# **Hydro News**

No. 231201

# ONSP Unit Radiator Change

To simplify radiator plumbing, SARIC radiator on NSP unit will be changed.

Table 1. NSP Unit Appearance and Shape (Picture shows 3.0, 16.0 c m³/rev series)

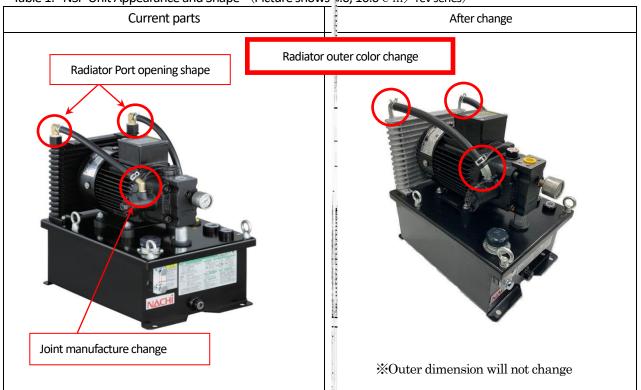
- •NSP unit outer dimension doesn't change from the current parts (Refer to Table 1, 2)
- •Radiator port opening shape, appearance color, with/without stay will be changed. (Refer to Table 3, 4)

Table 3. Radiator Outer Shape

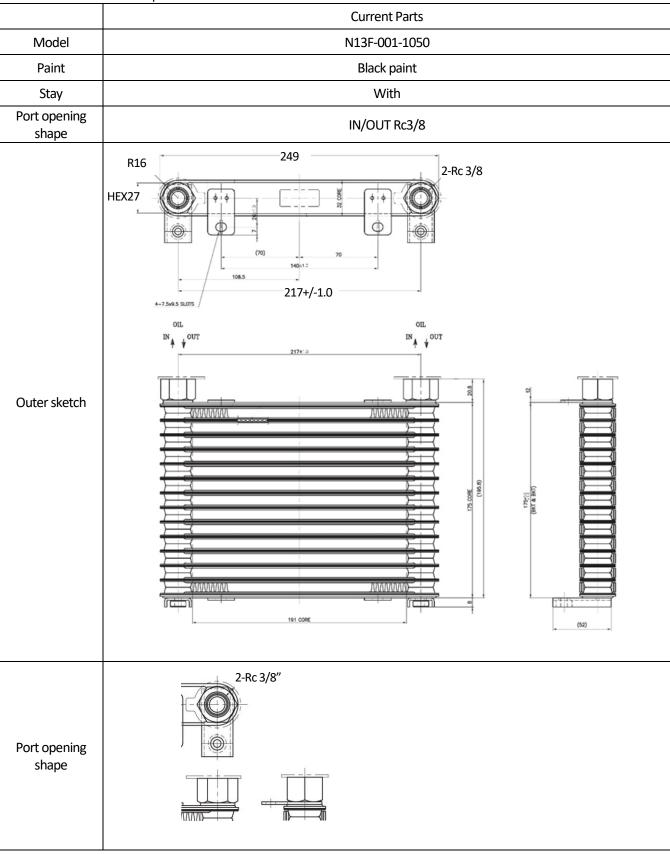
•Radiator (refer to Table 3, 4)

Item	Current parts	After change
Maker	SARIC	SARIC
Model	N13F-001- <b>1</b> 050	N13F-001- <b>2</b> 051
Color	Black paint	No paint (Aluminum color)
Stay	With	Without
Port opening shape	IN/OUT : Rc3/8	IN/OUT : Pipe shape

After change	
Model	N13F-001-2051	
Paint	No paint (Aluminum color)	
Stay	Without	
Port opening shape	IN/OUT PIPE shape	
Outer sketch	108.5 217+/-1.0 30 30 30 191 CORE	
Port opening shape	40

$\label{thm:continuous} \mbox{Tab} \underline{\mbox{le 5. Joint manufacture change (Pump drain opening side } 45\mbox{`elbow)} \ )$

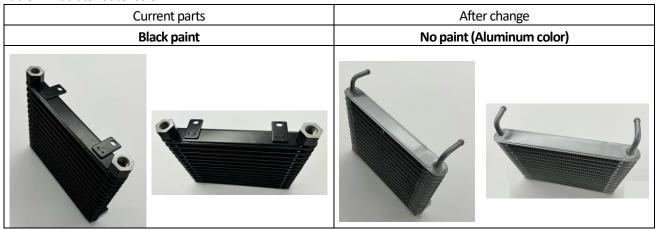
Pump drain port side joint manufacture will be changed.
